## **COMPTON SUBDIVISION**

APPLICATION NUMBER 16 DATE February 17, 2005

REQUEST Subdivision

# COMPTON SUBDIVISION

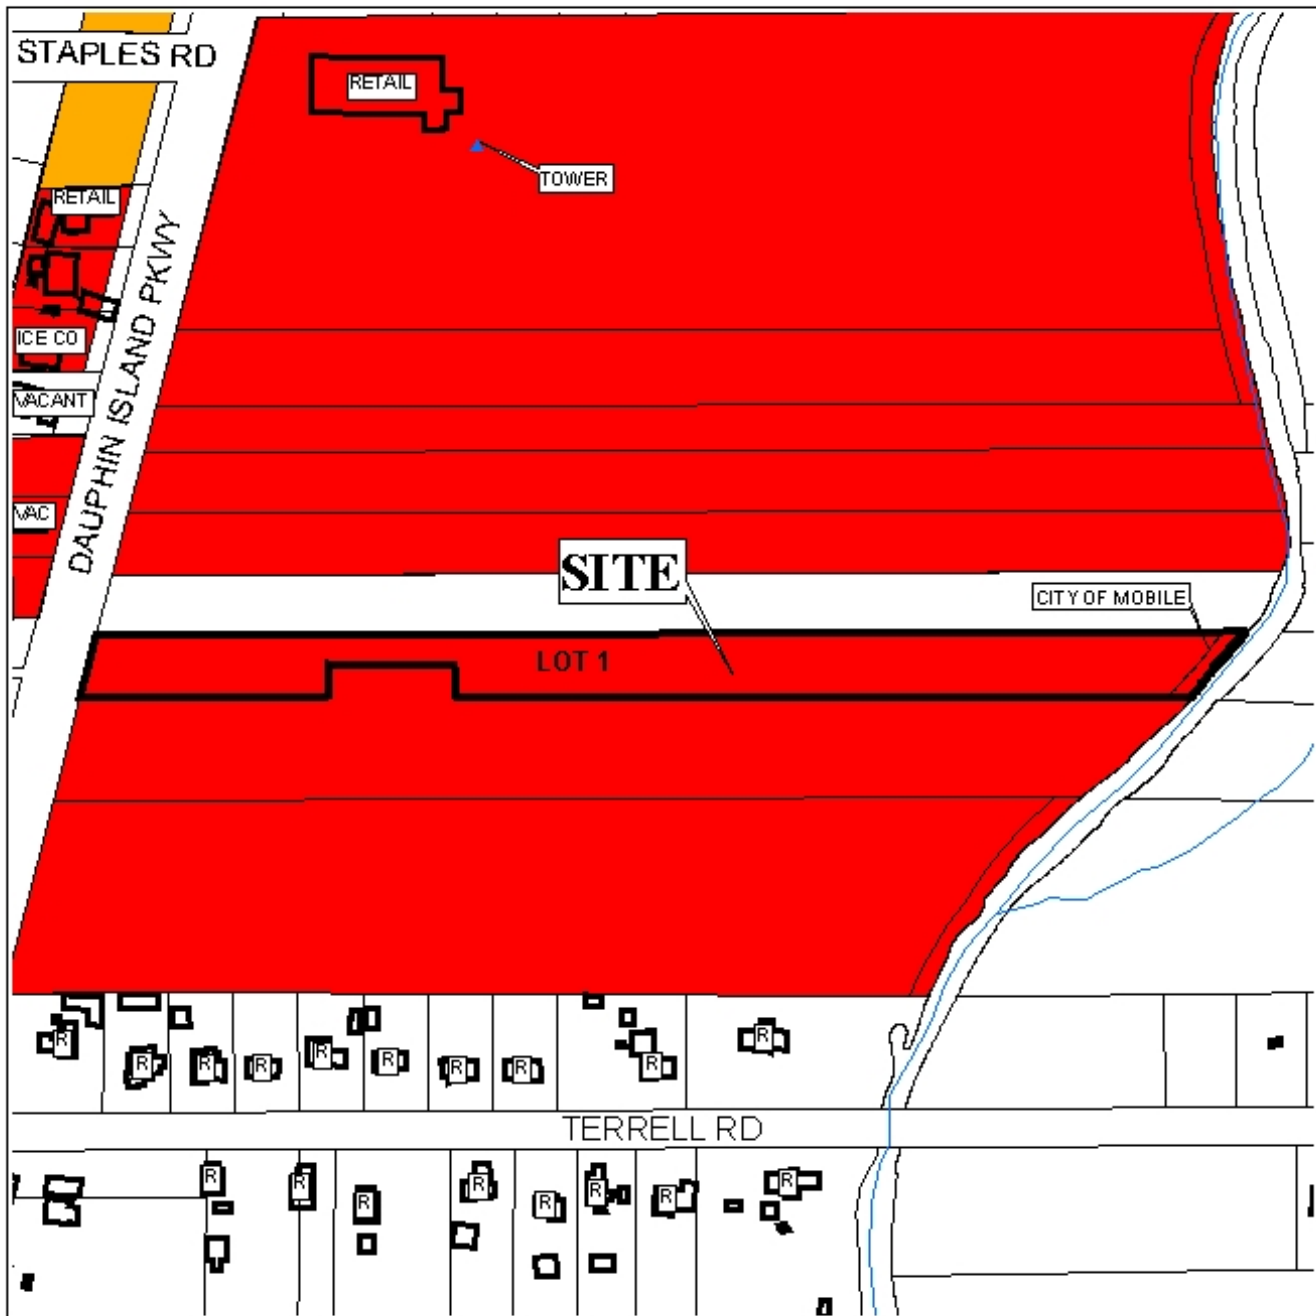
Although issues outlined above may be addressed administratively, it is recommended that this subdivision application be held-over pending submission of additional information by the applicant. As illustrated on the Vicinity Map, it appears that a portion of the property is not included in the proposed subdivision. To address the holdover issue, the applicant needs to either: 1) include the balance of the property in the subdivision application; or 2) needs to submit documentation that the property was a non-conforming lot of record prior to 1952.

Based upon the proceeding, this subdivision is recommended for Holdover until the March 3, 2005 Planning Commission meeting in order to address: 1) the inclusion of the balance of the property in the subdivision application; or 2) the submission of documentation that the property was a non-conforming lot of record prior to 1952. Information supporting the subdivision application must be submitted by February 16, 2005.
